Access Compliance Report

Public Rights-of-Way

(Curb Ramps)

Intersection ID: 48166	Main Street: NORTHLAKE_MALL_DR	Cross Street: NORTHLAKE_CENTRE_PY	Location: NE
ADA ID: F1828679AC7B	Ramp Type: Perp	Initial Pass/Fail: Fail	Overall Compliance: No
Severity Score: 12.5			
Codes/Mitigation Info/Possible Solution		Field Measurements/Component Compliance

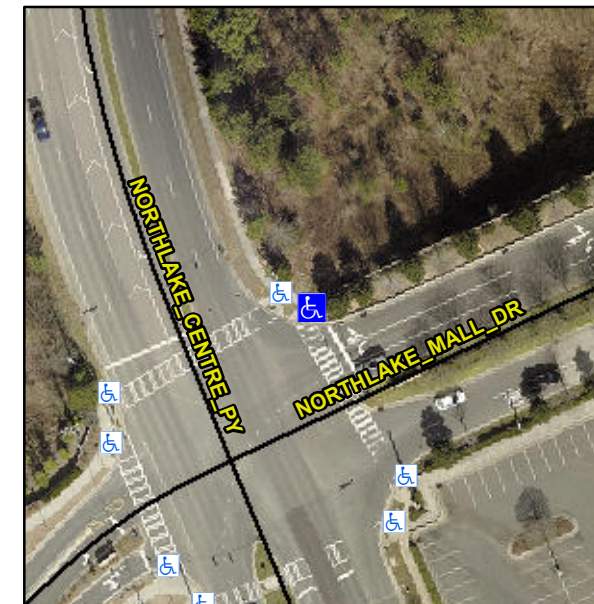
Not Found, R304.5.3

Compliance	Description	Data	Compliance	Description	Data
N/A	Ramp Length (in)	84.0	Yes	Ramp Slope (%)	7.0
Yes	Ramp Width (in)	54.5	No	Ramp XSlope (%)	6.6
N/A	Flare Type LT	N/A	N/A	Flare Type RT	N/A
N/A	Flare Slope LT (%)	N/A	N/A	Flare Slope RT (%)	N/A
N/A	Flare Traversable LT?	N/A	N/A	Flare Traversable RT?	N/A
N/A	Landing Length (in)	N/A	N/A	DWS Provided?	N/A
N/A	Landing Width (in)	N/A	N/A	DWS Contrast?	N/A
N/A	Landing Slope (%)	N/A	N/A	DWS Length (in)	N/A
N/A	Landing X Slope (%)	N/A	N/A	DWS Full Width?	N/A
N/A	Landing Curb? (Y/N)	N/A	N/A	DWS Offset (in)	N/A
N/A	Shared Landing?	N/A			
N/A	Gutter Ponding?	N/A	N/A	Gutter Slope (%)	N/A
N/A	Gutter Lip Ht (in)	N/A	N/A	Gutter X Slope (%)	N/A
N/A	Painted X Walk1?	Yes	N/A	Painted X Walk2?	N/A
	X Walk 1 Direction	To SE		X Walk 2 Direction	N/A
N/A	X Walk 1 Width (in)	104.0	N/A	X Walk 2 Width (in)	N/A
	X Walk 1 Slope (%)	3.8		X Walk 2 Slope (%)	N/A
	X Walk 1 X Slope (%)	2.9		X Walk 2 X Slope (%)	N/A

Remove & Replace Entire Ramp.
